U.S. ROUTE 5 HARTFORD AVENUE

ADDENDUM #1: REVISED APRIL 18, 2007

PROJECT NAME:	HARTFORD	PLOT DATE:	4/18/2007
PROJECT NUMBER:	RS 0113(40)	DRAWN BY:	E. ATKINS
FILE NAME:	z86c027xsl.dgn	CHECKED BY:	K. ISHIKURA
PROJECT LEADER:	KEN UPMAL	SHEET	200 OF 239
DESIGNED BY:	E. ATKINS

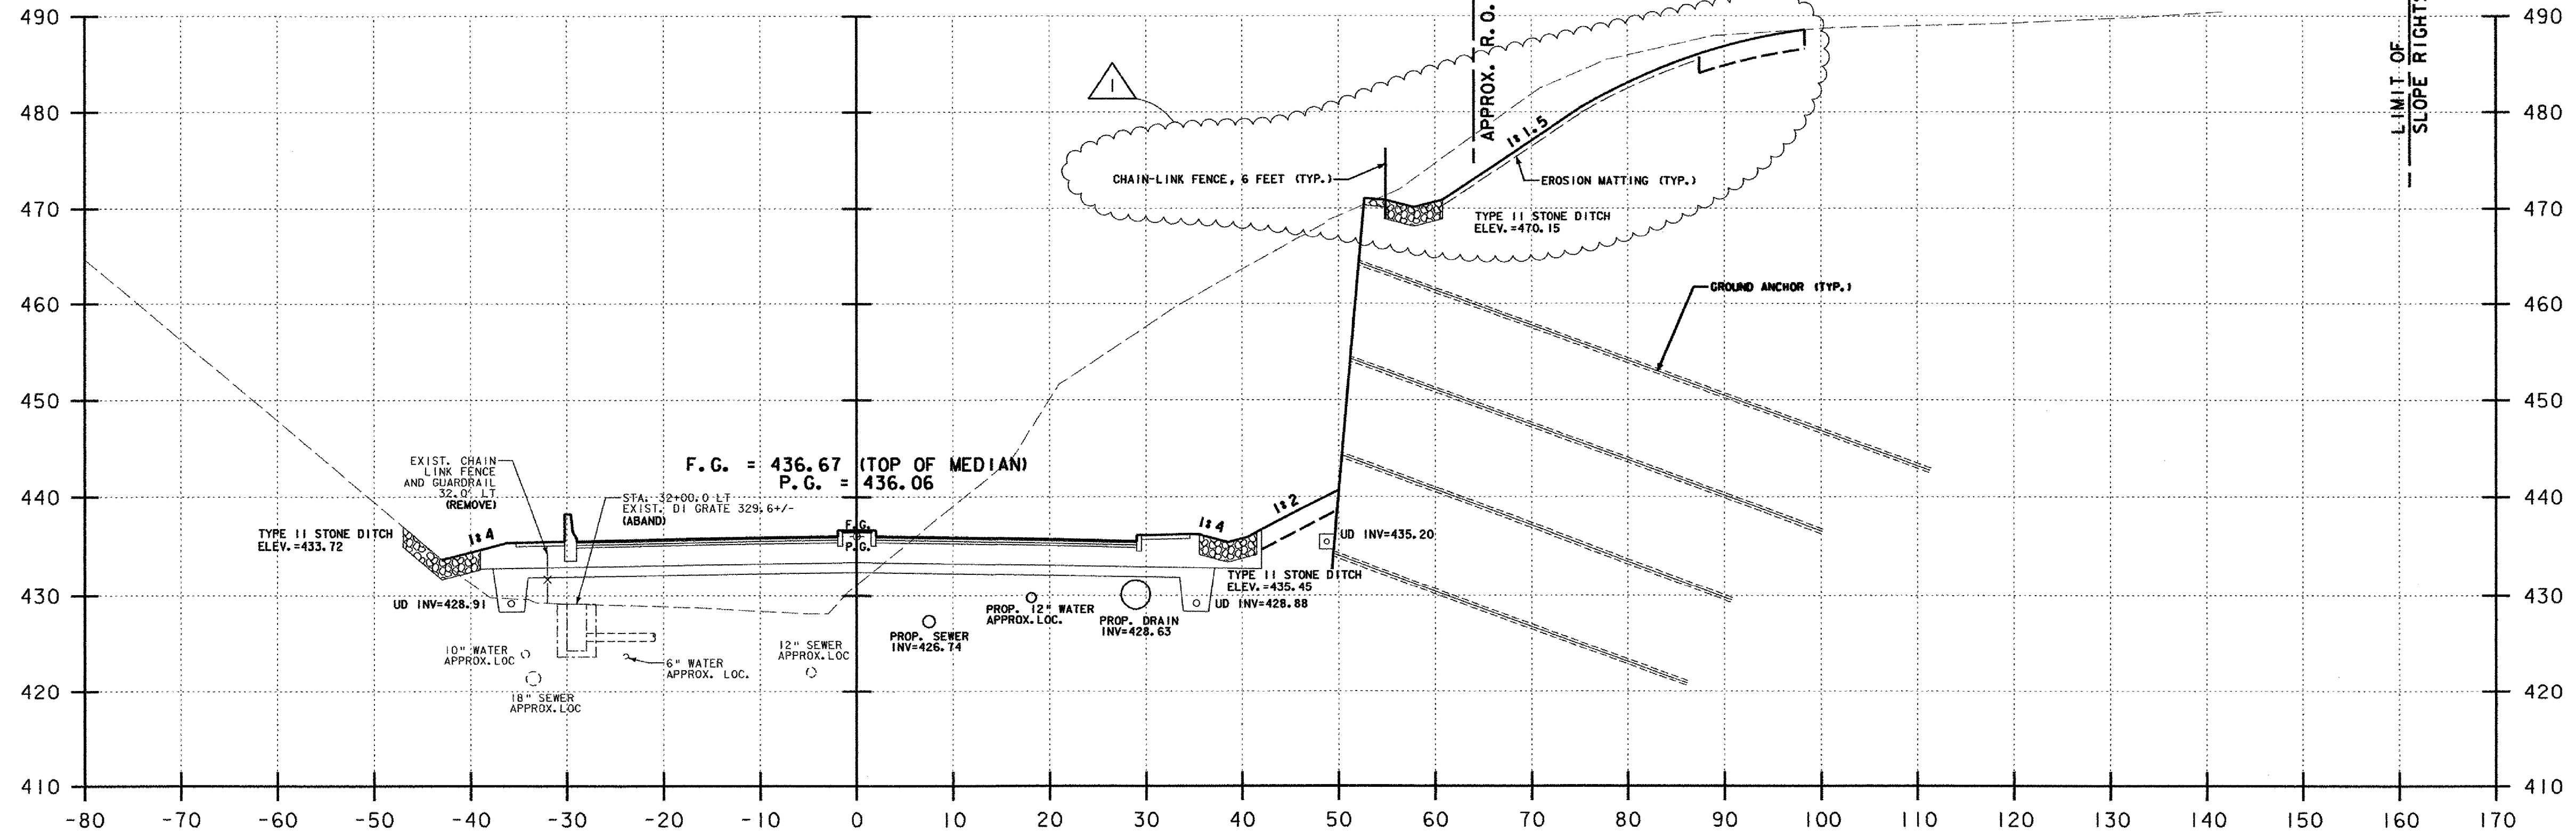
SEE VALUE ENGINEERING
RETAINING WALL
